**Aboriginal Affairs & Northern Development Canada - Information
Request Responses - Gahcho Kue Project Environmental Impact Review**

GAHCHO KUÉ PROJECT ENVIRONMENTAL IMPACT STATEMENT
INFORMATION REQUEST RESPONSES

Information Request Number: AANDC_1

Subject: Water Quality Objectives for Kennady Lake and the Downstream Receiving Environment

Figure AANDC 4-1: Predicted Total Dissolved Solids (TDS) concentrations in Kennady Lake areas

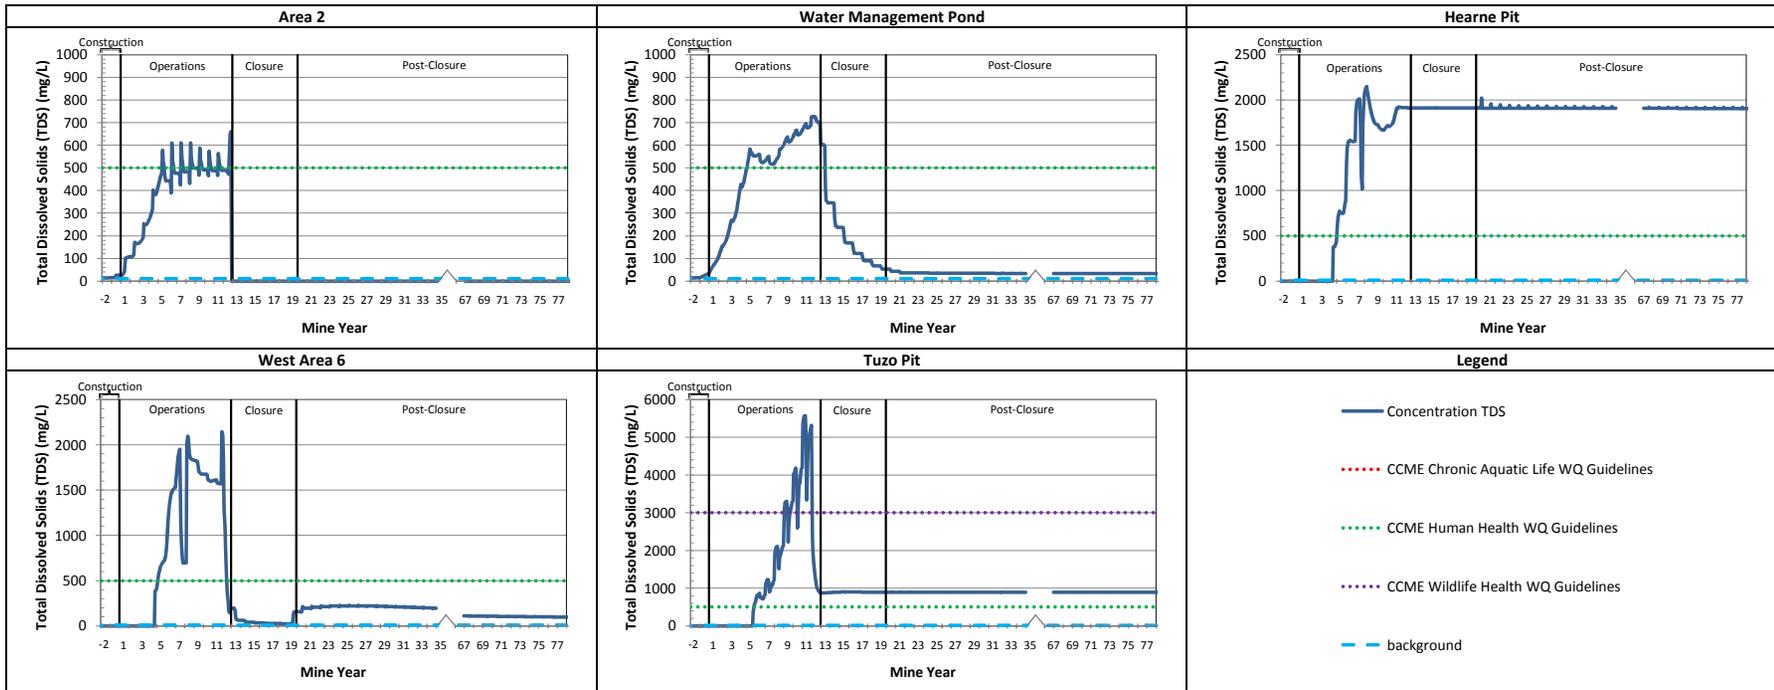
4. What is the water quality of the water above the PK in the Hearne Pit? What is the water quality of the Tuzo Pit? What is the expected schedule of water quality over the life of the mine and variations seasonally, how will DCI deal with it over the mine life and into the closure period?

The simulated water quality in Area 2, the water management pond, and the Hearne pit will be variable and a function of the various source waters reporting to each area. To illustrate this, simulated TDS concentrations in each of these areas is provided in Figure AANDC_4-1. Simulated concentrations of other specific parameters can be made available to AANDC upon request. It is important to note that hydrodynamic modelling of the Hearne Pit for the 2012 EIS Supplement indicates meromixis will occur in the pit. As such, the concentrations provided in Figure AANDC_4-1 represent the water quality below the pycnocline (or chemocline). This water is isolated and does not mix with the overlying Kennady Lake in the water quality assessment. The water above the pycnocline is assumed to be fully mixed in Area 6 of Kennady Lake. The simulated TDS concentrations for this area are also provided in Figure AANDC_4-1. Additional details related to the hydrodynamic modelling are provided in Section 8 of the 2012 EIS Supplement (De Beers 2012).

In the 2011 EIS Update (De Beers 2011), the water quality in Hearne pit above the fine PK was assumed to be fully mixed. As such, the water quality above the fine PK was considered to be similar to the mixed concentrations presented in Figure AANDC_4-1. As indicated in Part 2 of this response, the water quality is dependent on several input sources and the quality will vary throughout the life of the mine. To illustrate this, simulated TDS concentrations in each of these areas is provided in Figure AANDC_4-1. Simulated concentrations of other specific parameters can be made available to AANDC upon request. Hydrodynamic modelling of Hearne pit completed for the 2012 EIS Supplement indicates that meromixis will develop in the Hearne pit, which will isolate the deeper, higher TDS water lying over the fine PK, and the concentrations presented in Figure AANDC_4-1 represent the water chemistry below the pycnocline.

The water quality of the Tuzo pit will also be a function of several input sources and will be variable throughout the life of mine. Simulated TDS concentrations for this facility are provided in Figure AANDC_4-1. Simulated results of other parameters can be made available to AANDC upon their request. Similar to the Hearne pit, hydrodynamic modelling of this pit also indicates meromixis will develop and the concentrations presented in Figure AANDC_4-1 represent the water chemistry below the pycnocline. The water above this elevation is considered to be fully mixed with Kennady Lake in the water quality assessment.
